ADDENDUM NO. 1

Date of Addendum: March 18, 2016

PROJECT NAME: Neighborhood Street Reconstruction Project No. 467

PROJECT NO: WBS No. N-000400-0001-4

WBS NUMBER
N-000400-0001-4
DRAWING SCALE
VERT. 1"=2' HORIZ. 1"=20'
CITY OF HOUSTON PM
BEN BANSAL, P.E.
SHEET No. 37 OF 226

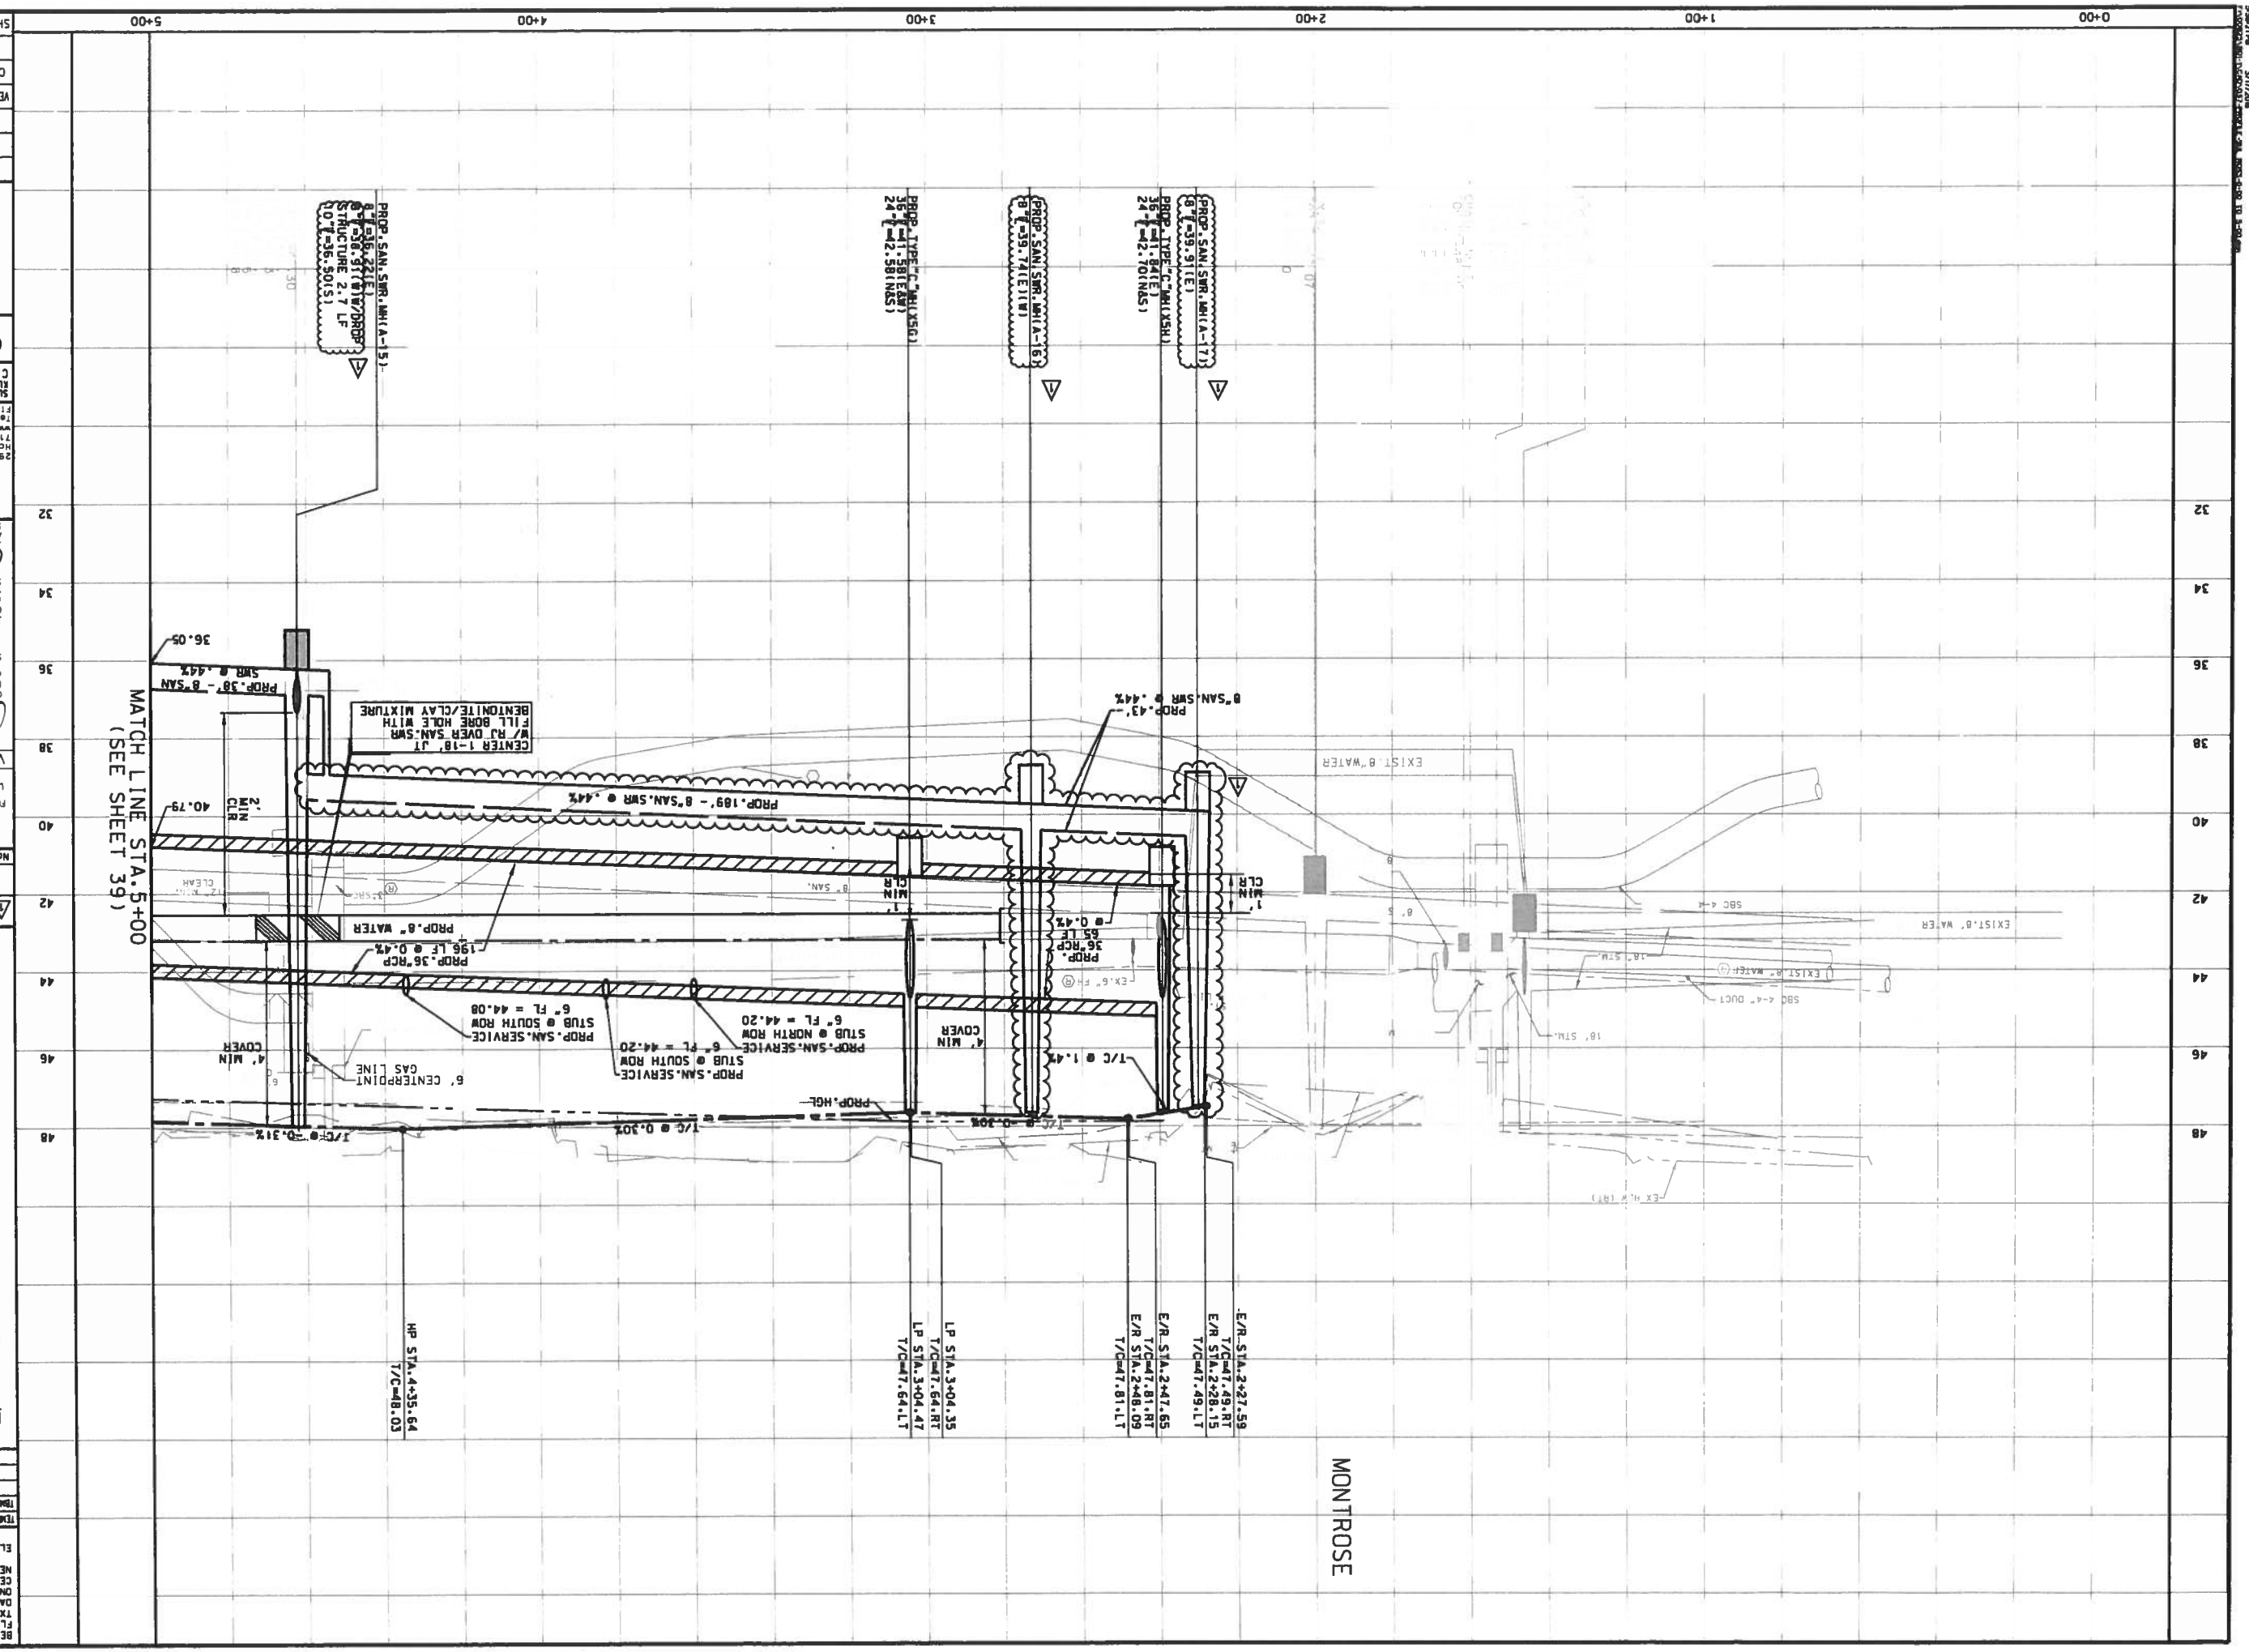
No.	DATE	REVISIONS	APP.
1	3/11	ADDENDUM #1 SAN.SWR. REVISED	M.A.W.

WBS NUMBER	
N-000400-0001-4	
DRAWING SCALE	
VERT. 1"=2' HORIZ. 1"=20'	
CITY OF HOUSTON PM	
BEN BANSAL, P.E.	
SHEET No. 38 OF 226

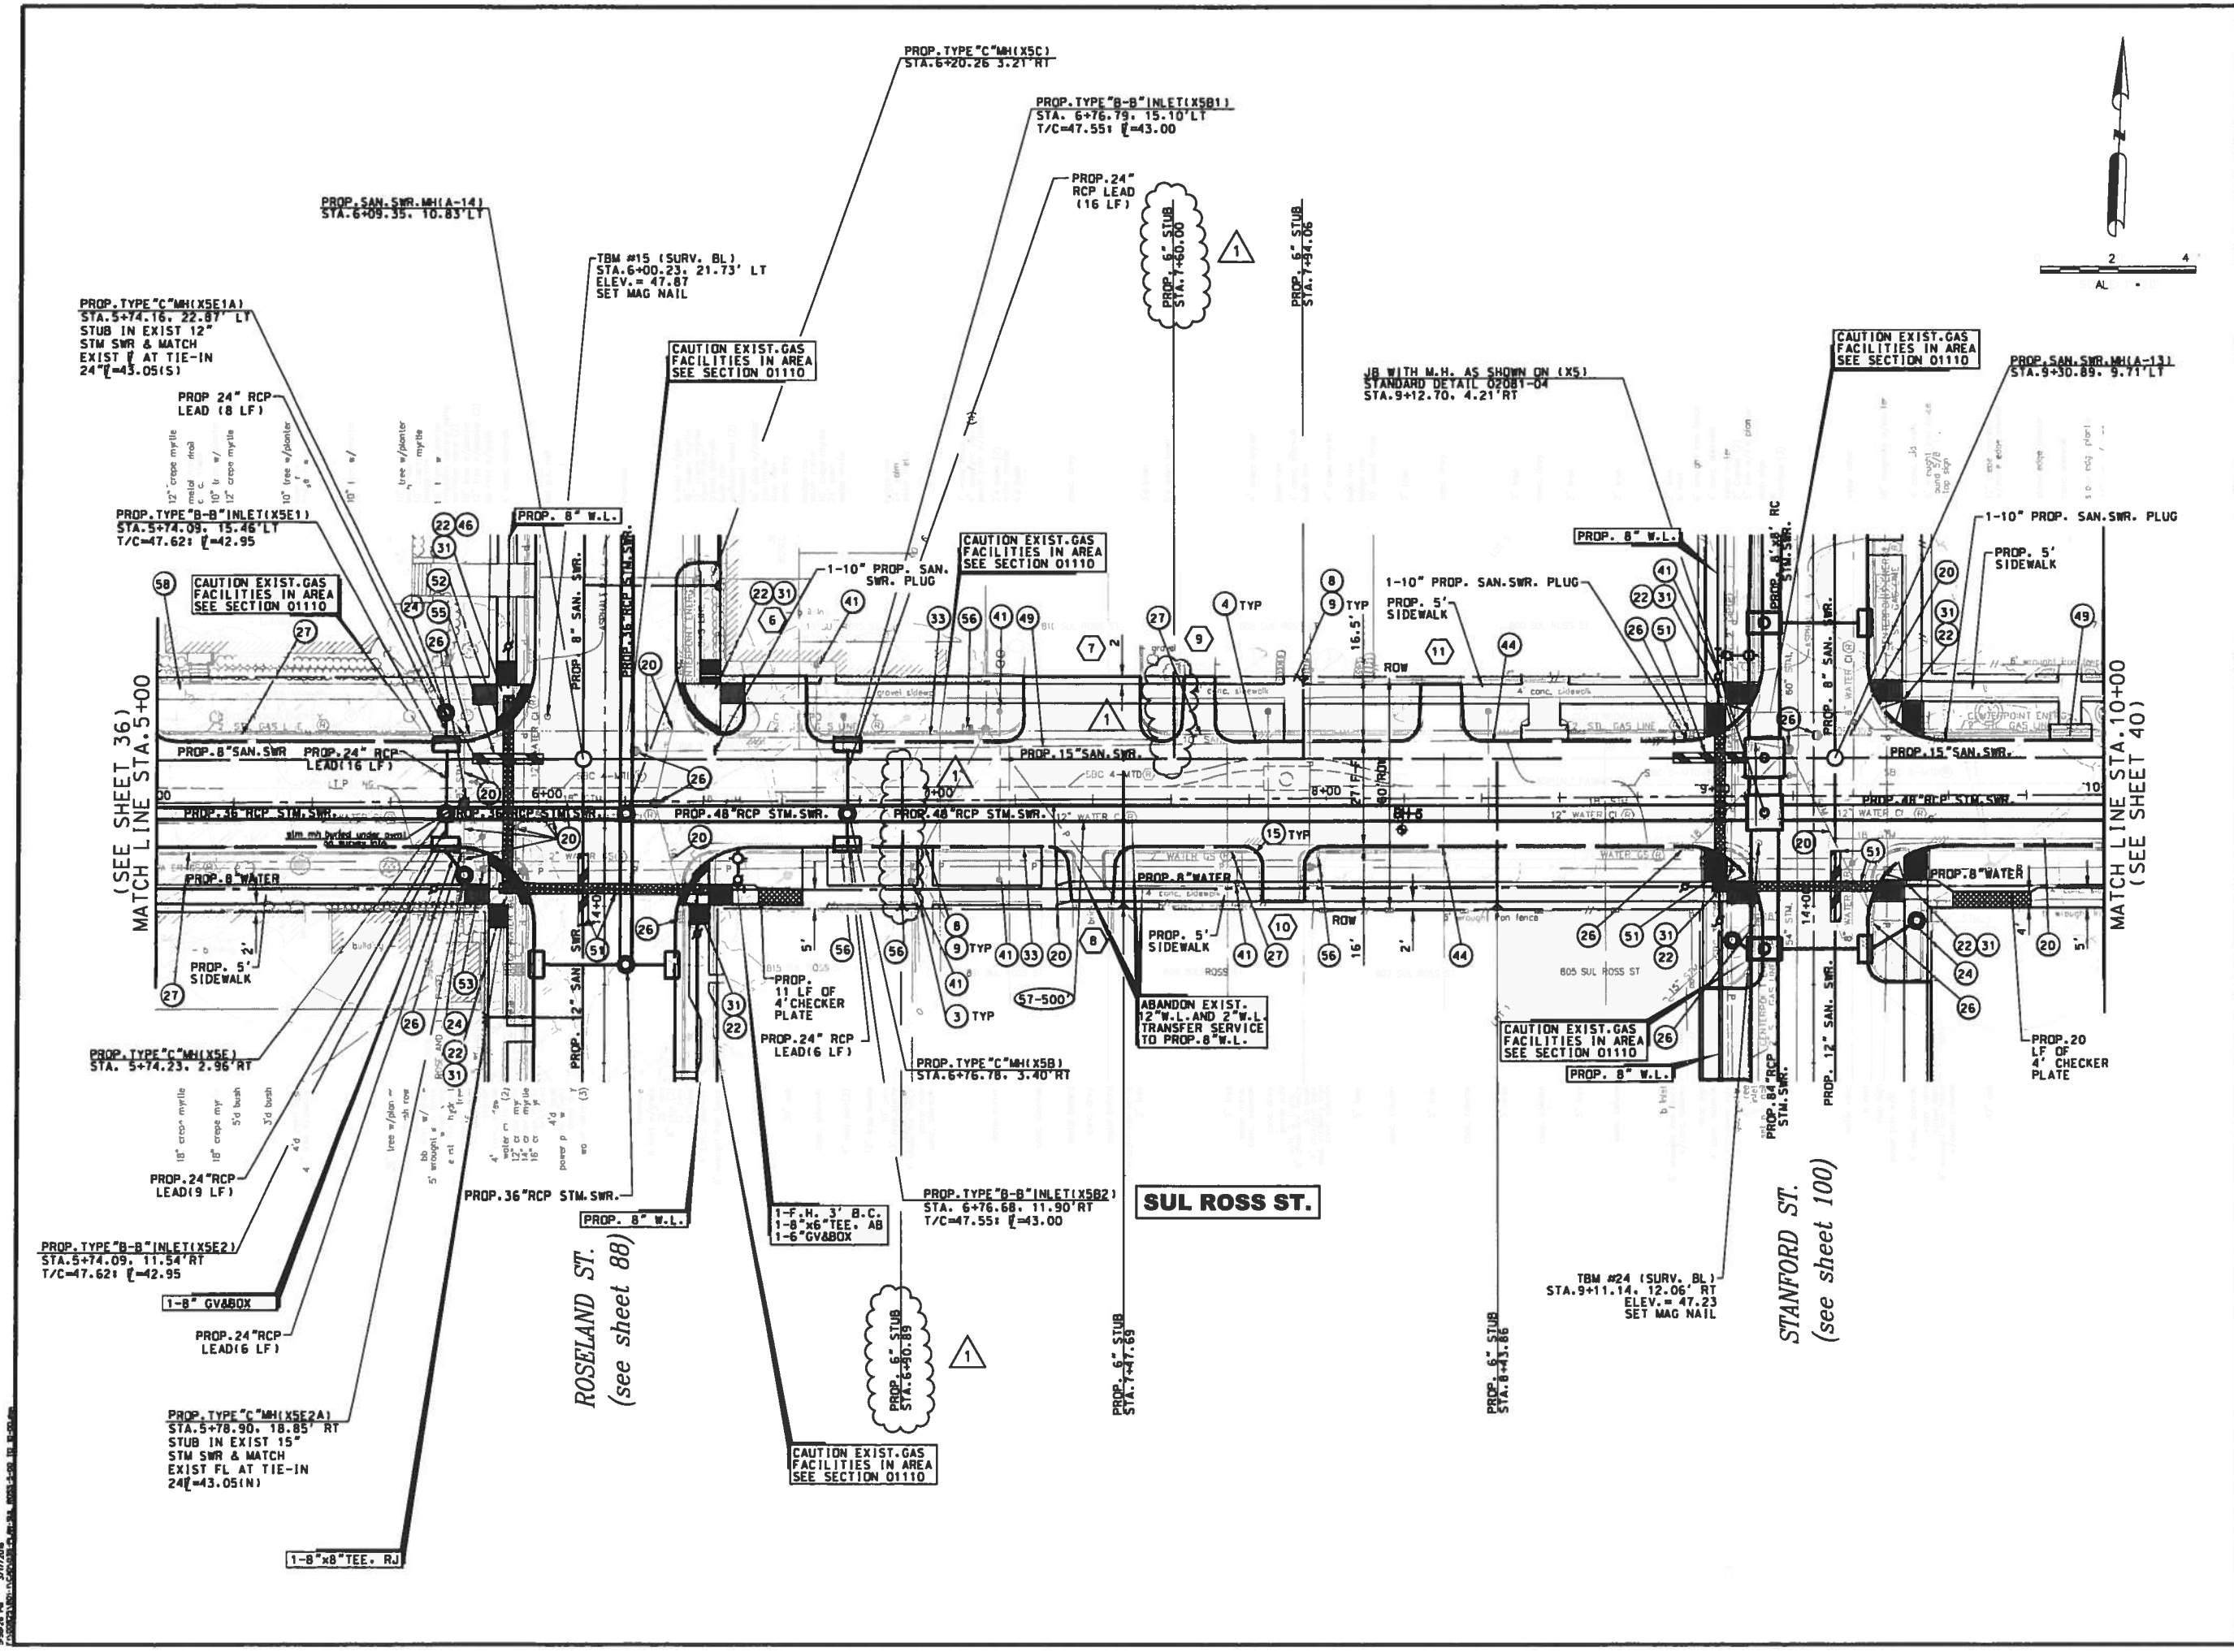
No.	DATE	REVISIONS	APP.
1	3/11	ADDENDUM #1 SERVICE STUBS REVISED	M.A.M.

WBS NUMBER	N-000400-0001-4
DRAWING SCALE	VERT. 1"=2' HORIZ. 1"=20'
CITY OF HOUSTON PM	BEN BANSAL, P.E.
SHEET No. 39 OF 226

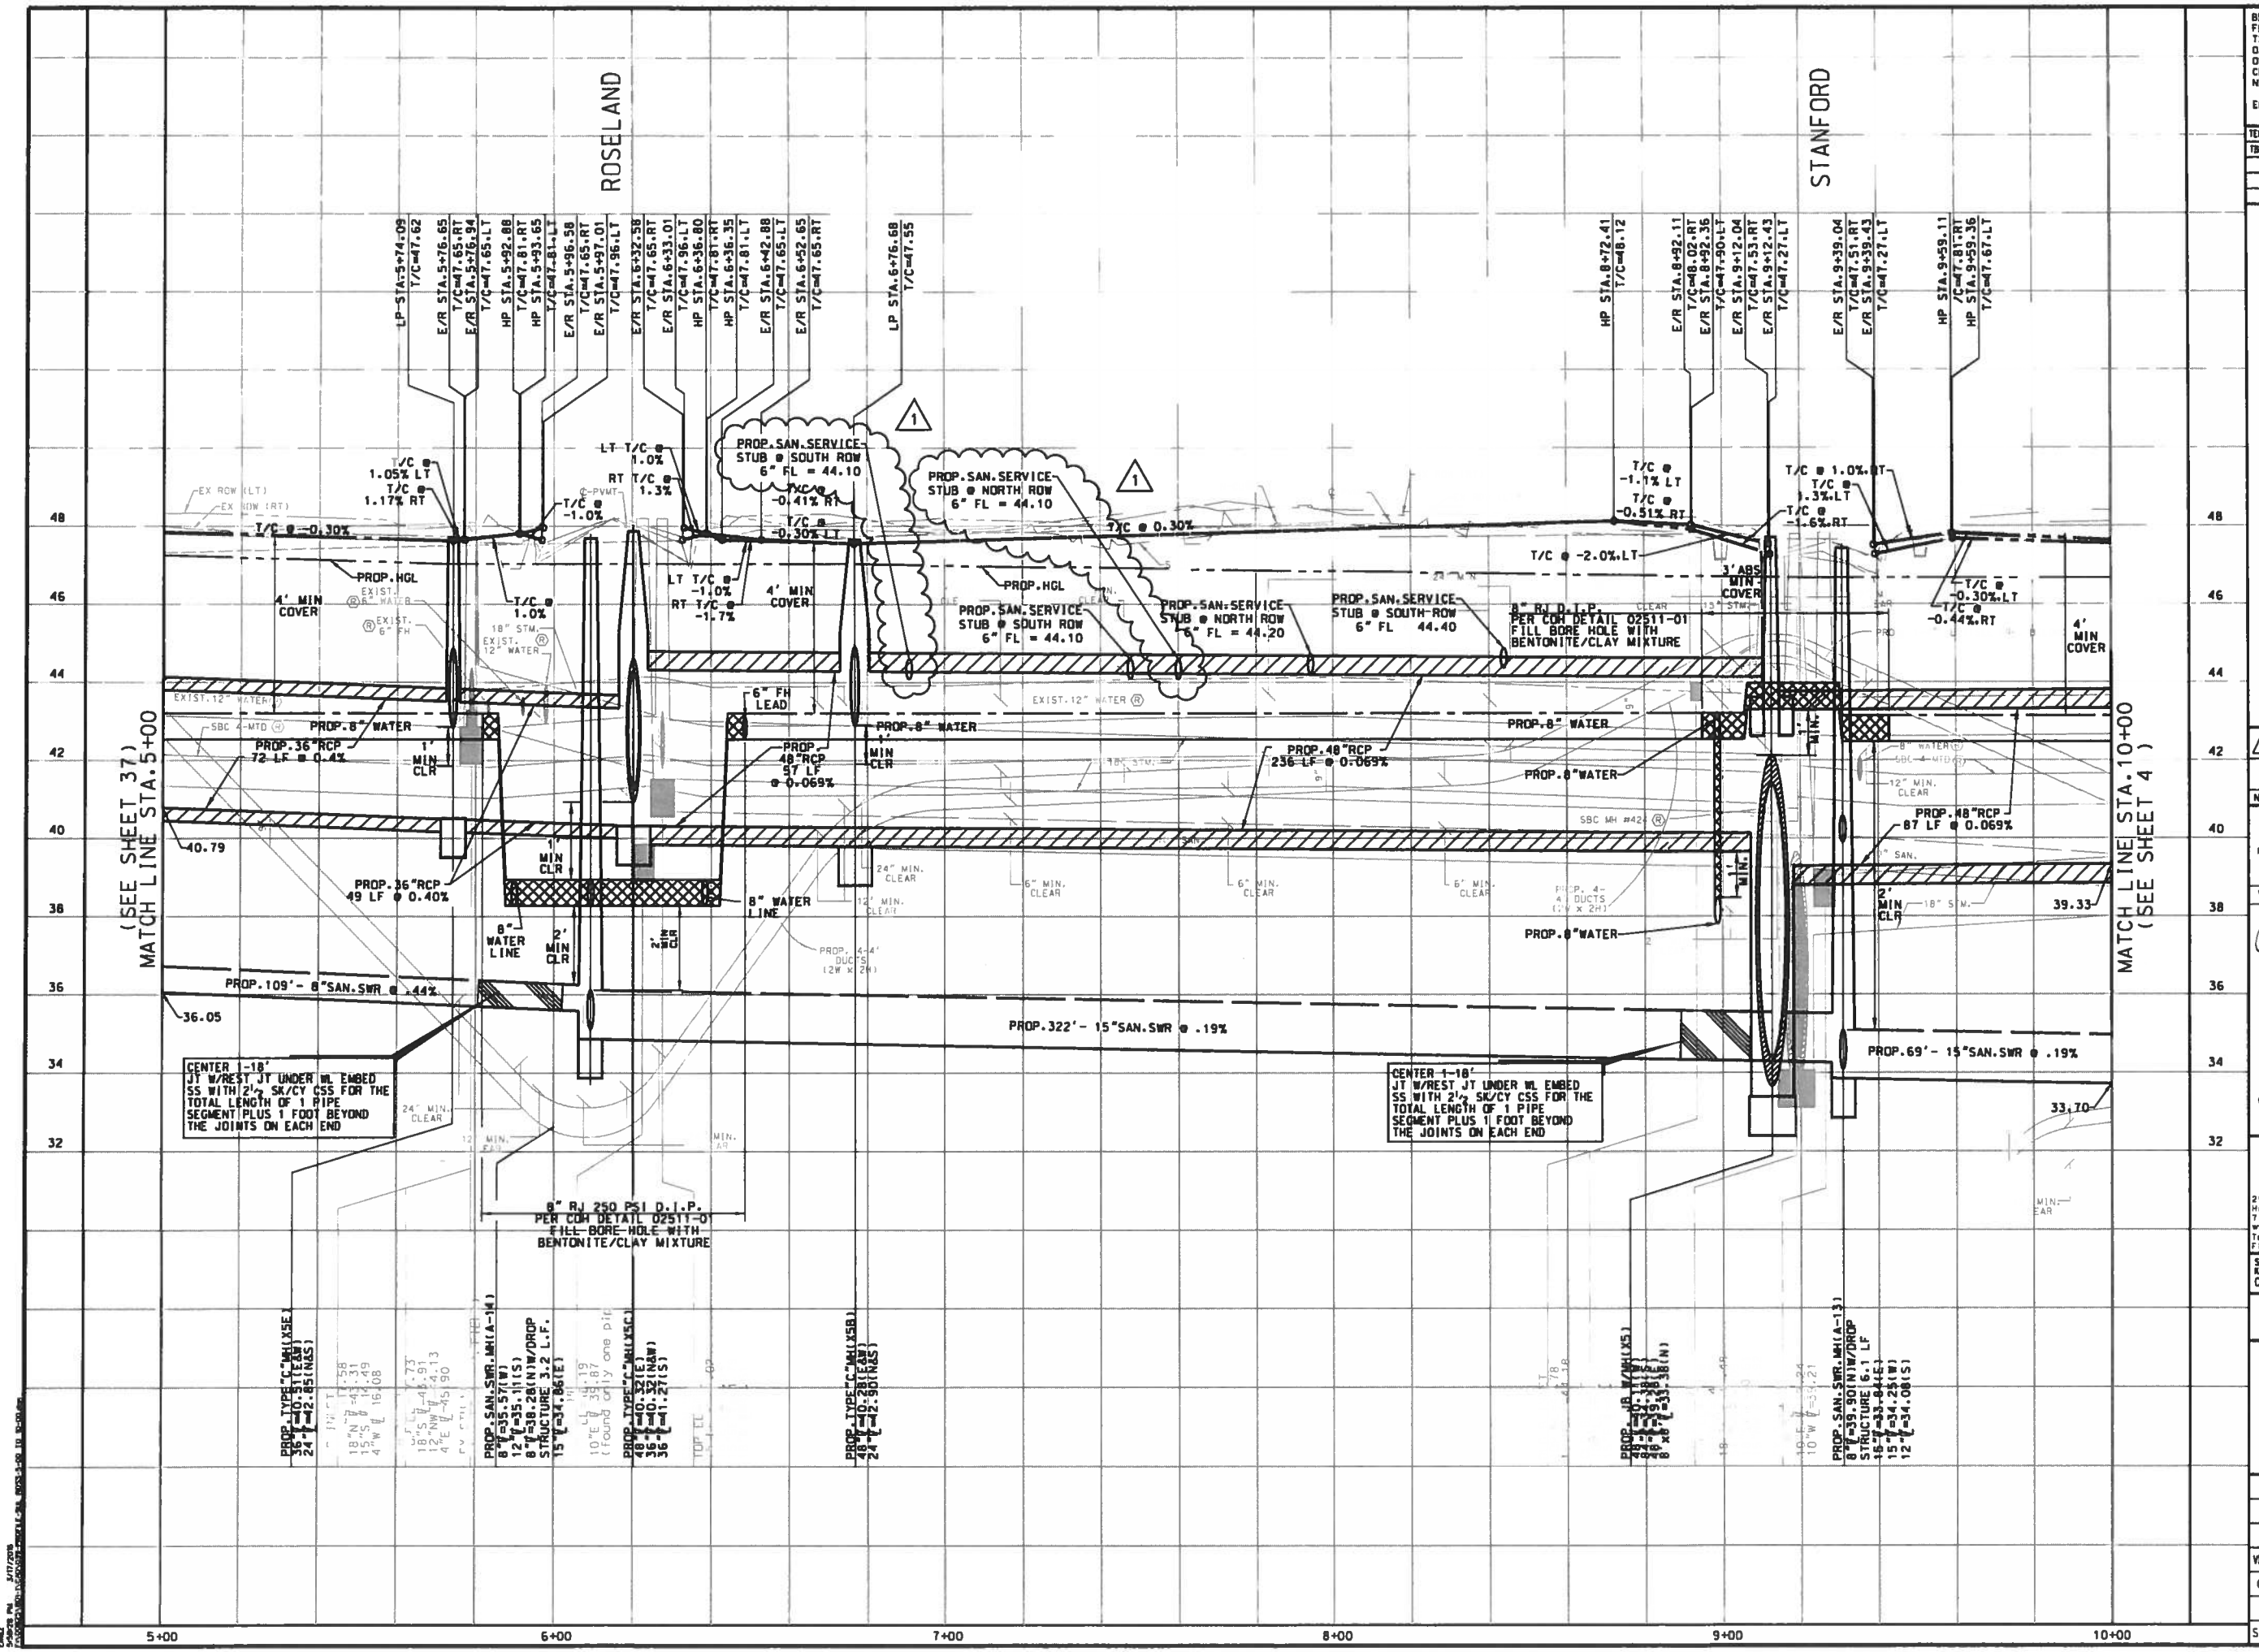
No.	DATE	REVISIONS	APP.
1	3/11	ADDENDUM #1 SERVICE STUBS REVISED	M.A.M.
